**Re: Tampa Electric Company
Big Bend Units 1 & 2 FGD System
Response to Request for Additional Information**

In response to your letter of August 5, 1998, Tampa Electric Company hereby provides the following responses to your request for additional information on the new FGD system for Big Bend Units 1 & 2. Responses to questions not addressed in this letter will be forwarded to you within the next few days.

FGD PROJECT
 PROCESS FLOW DIAGRAM
 GAS FLOW

PROCESS FLOW DIAGRAM

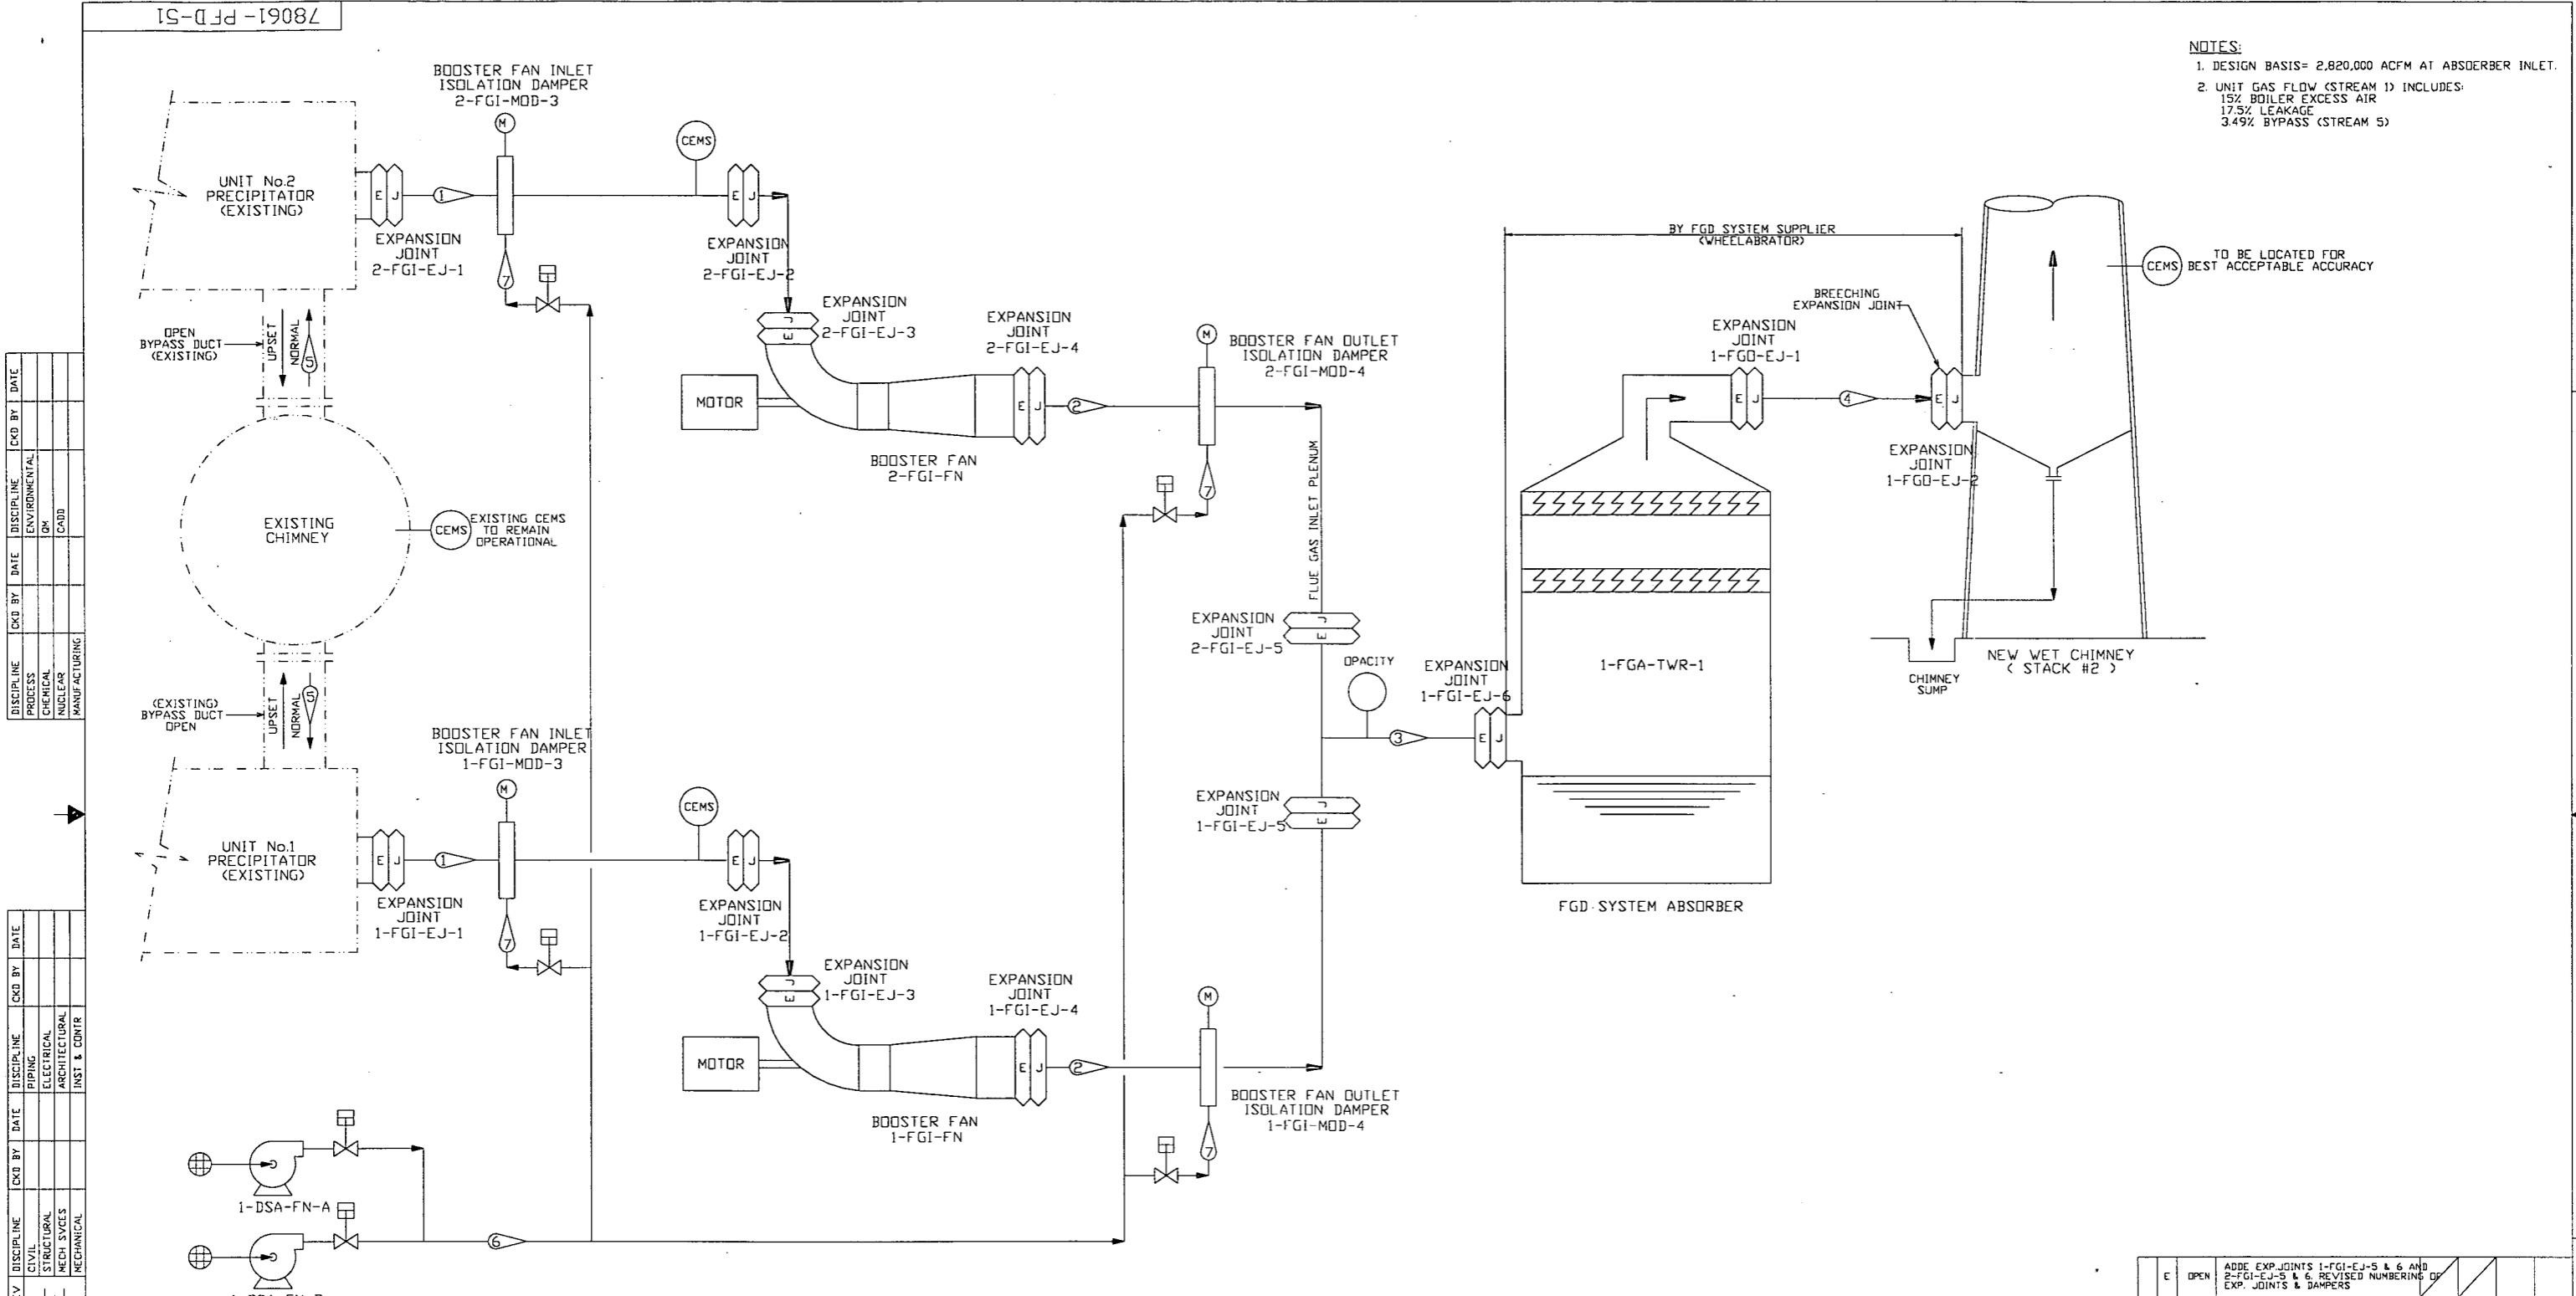
Please provide a process diagram of the proposed FGD system showing pertinent gas and liquid streams.

Please see the attached process diagrams.
